Piper Aircraft Corporation

**SUBJECT:** Replacement or Modification of Muffler Shrouds

**MODELS AFFECTED:** PA-24 and PA-24 "250" Comanches - Serial Numbers 24-2588 to 24-2875 incl., 24-2877 to 24-2928 incl., 24-2930 to 24-2948 incl., 24-2950 to 24-2966 incl., 24-2968 to 24-2989 incl., 24-2991 to 24-3032 incl., 24-3034 to 24-3094 incl., 24-3096 to 24-3113 incl., 24-3115 to 24-3129 incl., 24-3131 to 24-3149 incl., 24-3151 to 24-3154 incl., 24-3156 to 24-3172 incl., 24-3174 to 24-3190 incl., 24-3192, 24-3195, 24-3197, 24-3199 to 24-3202 incl., 24-3205 to 24-3221 incl., 24-3223 to 24-3232 incl., 24-3235 to 24-3240 incl., 24-3242, 24-3243, 24-3245, 24-3246, 24-3247, 24-3249 to 24-3253 incl., 24-3255, 24-3256, 24-3259 to 24-3264 incl., 24-3266, 24-3267, 24-3269, 24-3271, 24-3272, 24-3275, 24-3281, 24-3284 and all of the referenced aircraft prior to Serial No. 24-2588 in which mufflers, part number 22594-00 and part number 22594-02 PA-24, and part number 22593-00 and part number 23159-00 PA-24 "250", have been installed as service replacements.

TEMPLATE  
NEW SHROUD HOLE  
ACTUAL SIZE

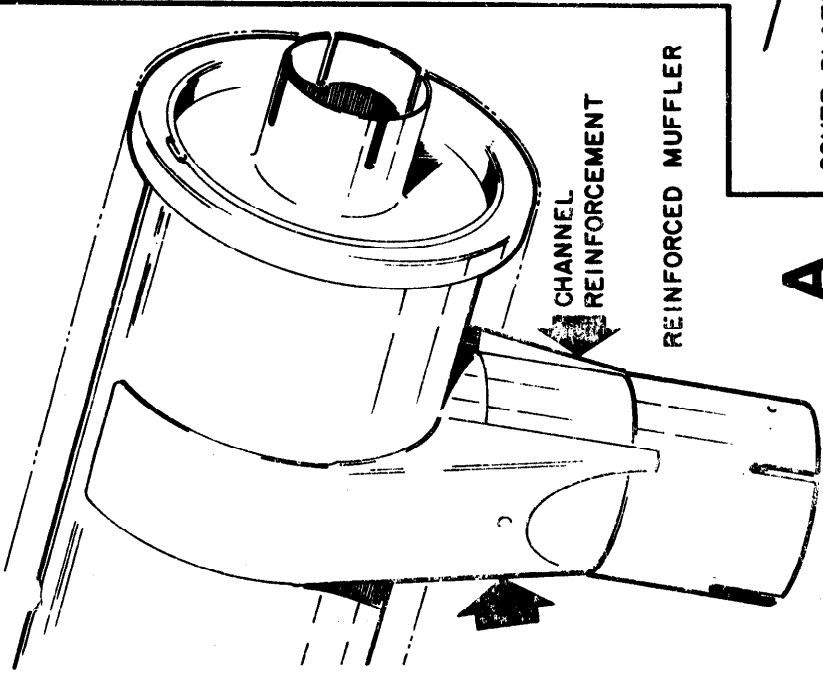
6. Remove the cold air inlet take-off assembly located on the aluminum heater shroud.
7. Cut out the enclosed template and place on the aluminum shroud over the present tailpipe opening.

RELOCAT. 2" DIA. TAKE-OFF HOLE  
SEE TAKE-OFF RELOCATION TABLE

ON SHROUDS WITH SPLICE AT 45°  
DO NOT CUTOUT OR RIVET  
ABOVE SPLICE

**A**

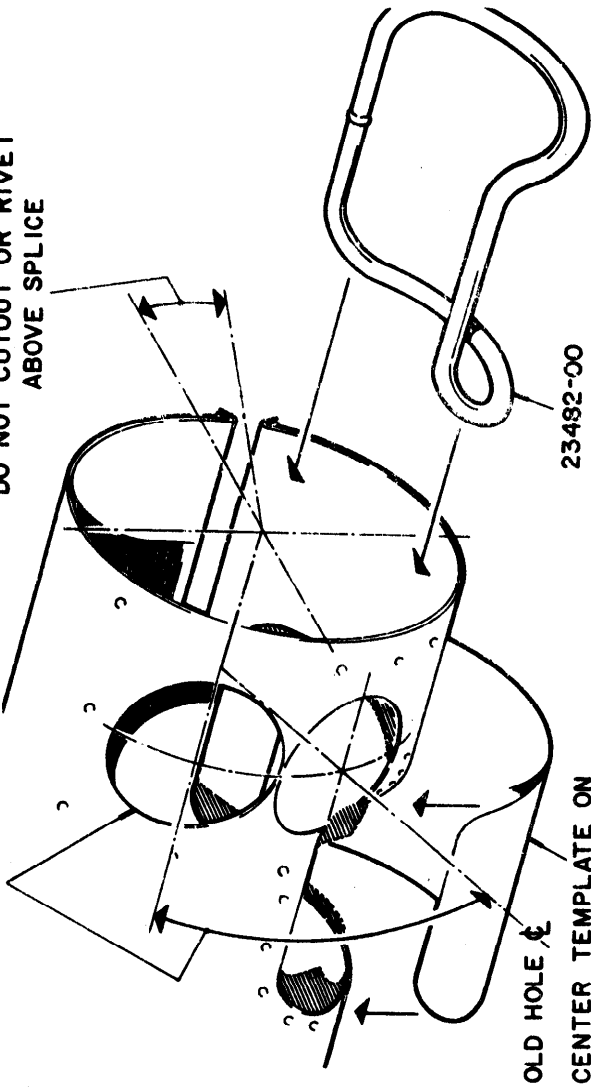
Comanche mufflers have been manufactured incorporating two different styles of tailpipe reinforcement brackets. However, this Service Bulletin requires modification of one style only; those with the channel-shaped reinforcement. See Sketch "A" for further identification. Both styles of muffler have been sold as service replacements. It will therefore be necessary to inspect aircraft, Serial Nos. 24-1 to 24-2587 inclusive if the original muffler has been replaced, to determine if compliance with this Bulletin is required.

**B**

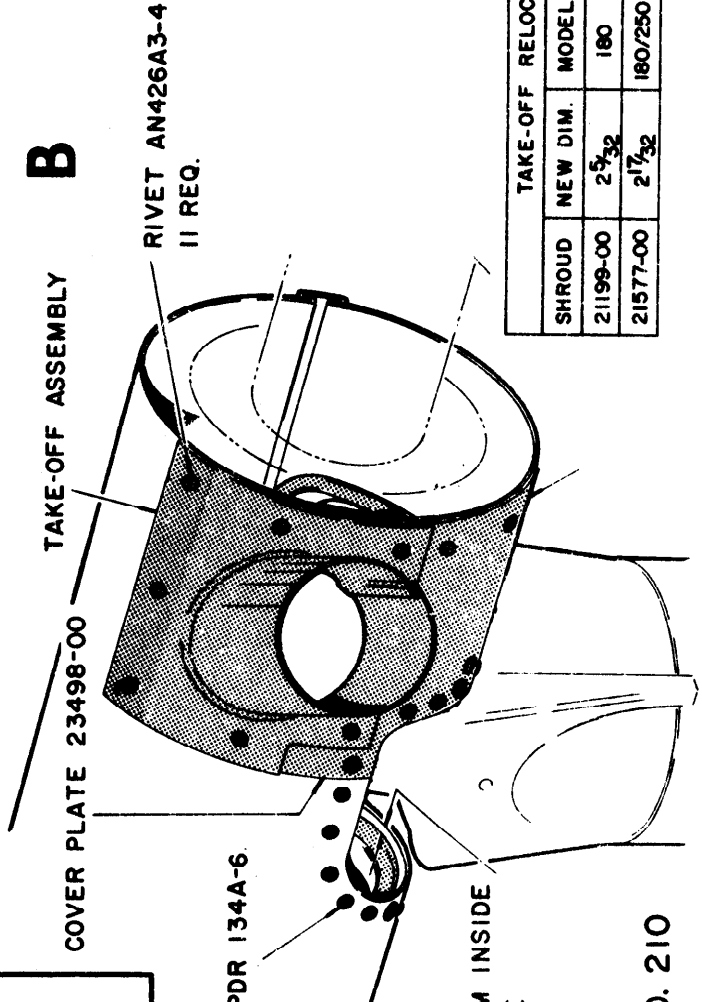
8. Cut the new opening in the aluminum shroud, taking care not to cut past the splice. (See Note Sketch "B.")
9. Install the muffler housing reinforcement tube, part number 23482-00, on the inside of the aluminum heater shroud. (See Sketch "B.")

10. Relocate the cold air inlet take-off assembly as shown on the take-off relocation table and install cover plate, part number 23498-00, over old hole. Trim cover plate as required. (See Sketch "B.")

OLD HOLE  
CENTER TEMPLATE ON  
OLD EXHAUST STACK HOLE  
USING ATTACHED TEMPLATE

23482-00

COVER PLATE 23498-00  
TAKE-OFF ASSEMBLY

CUTOUT APPROX. 1/8" FROM INSIDE  
OF REINF. TUBE
